**45-DAY EXPRESS TERMS FOR
PROPOSED BUILDING STANDARDS OF
THE CALIFORNIA DEPARTMENT OF PUBLIC HEALTH**

**REGARDING PROPOSED CHANGES TO
CALIFORNIA CODE OF REGULATIONS,
TITLE 24, PART 2 CHAPTER 31 B PUBLIC SWIMMING POOLS**

(APPROVED AND EFFECTIVE 07/01/15)

FIGURE 31B-8

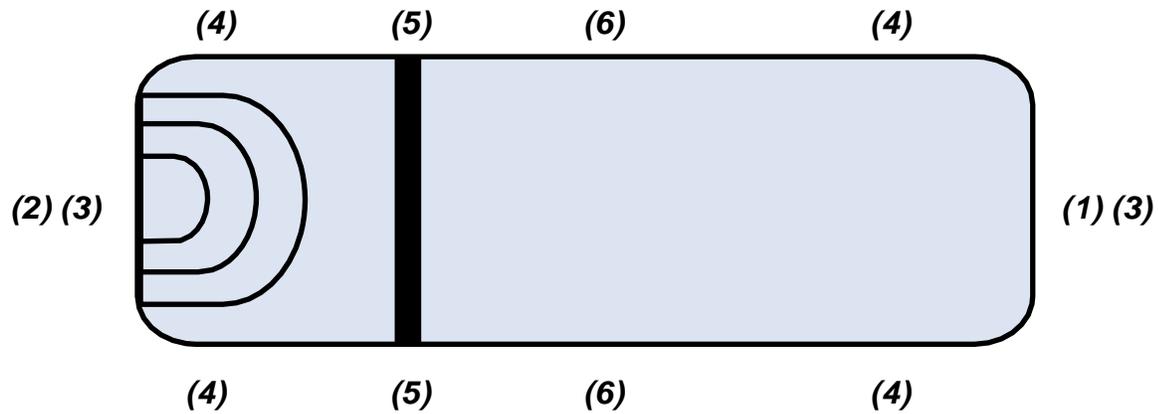
3110B.4.1 Location. *The water depth shall be clearly marked at the following locations:*

1. *Maximum depth; and*
2. *Minimum depth; and*
3. *Each end; and*
4. *Both sides at ~~each end~~ the shallowest and deepest part of the pool; and*

Note: *For an illustration diagram pertaining to this section see Figure 31B-8.*

15) Add FIGURE 31B-8 as follows:

1. *Maximum depth.*
2. *Minimum depth.*
3. *Each end of pool.*
4. *Both sides at the shallowest and deepest part of pool.*
5. *At the break in the bottom slope between the shallow and deep end.*
6. *Along the perimeter of the pool at distances not to exceed 25 feet.*
